City of Santa Fe, New Mexico

memo

2025-010494-HDRB, 206 McKenzie St., Downtown and Eastside Historic District, Contributing, Bradyn Furry, agent for Mindy Hale and FC3 Ltd. Co., owner, requests approval to replace all the doors and windows which requires an exception to 14-5.2(D)(1)(a) for the removal of historic material; construct a new detached steel carport to a height of 8'-8" with roof-mounted solar units within the existing auto court which requires an exception to 14-5.2(D)(E) Downtown and Eastside Design Standards; an increase in height by 3'-3" of a previously approved parapet on the McKenzie St. façade which requires an exception to 14-5.2(D)(2)(c) additions are not permitted unless set back 10' from primary facade, and install roof top HVAC units, and a new pedestrian gate on the McKenzie St. adjacent to the vehicle entrance.

Figure 1. Primary Facade Diagram,

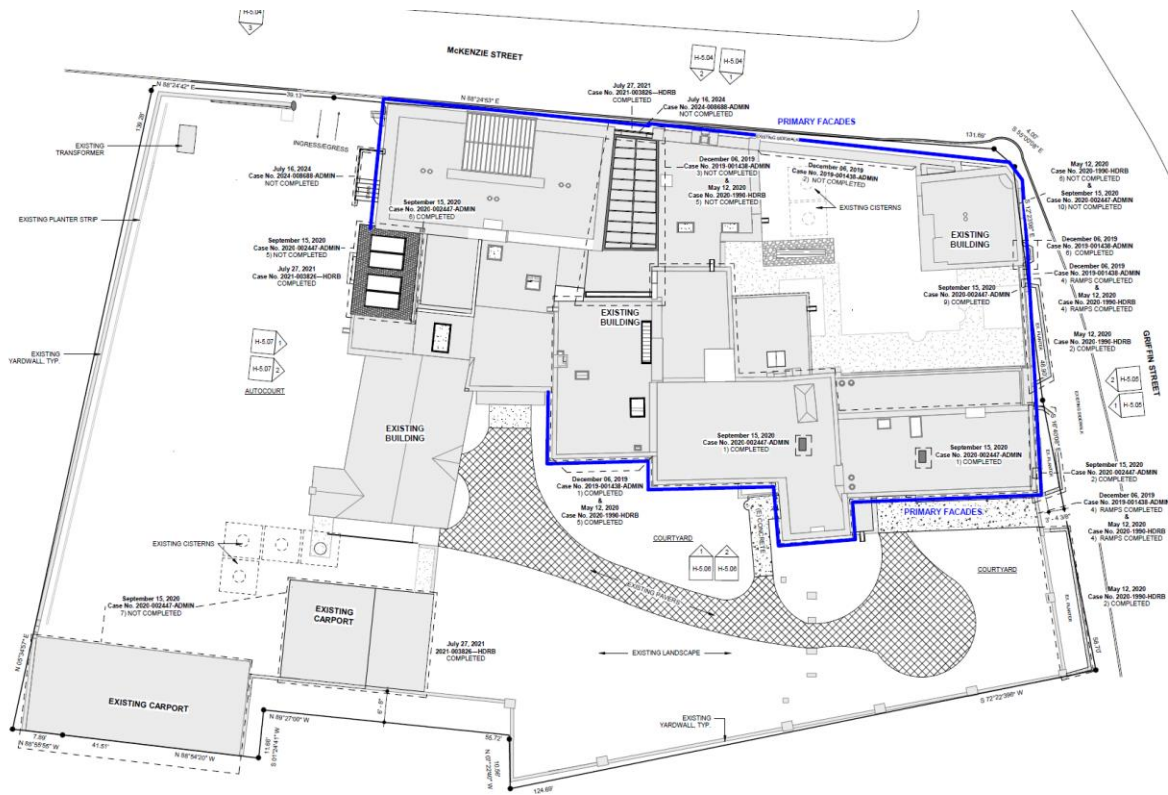
The mixed-use commercial and multi-family complex at 206 McKenzie Street is listed as contributing to the Downtown and Eastside Historic District with the north, east, and partial southern and western facades designated as primary. The original structure has been identified in the 2005 Historic Cultural Properties Inventory (HCPI) survey form to have been constructed pre-1766 to 1846 with several changes from the 1930s and 1940s into the present. The unique eclectic nature of the structure and location on the Grant Avenue and McKenzie Street streetscape has made this structure a stand-alone complex unmirrored by anything seen in the Downtown and Eastside Historic District.
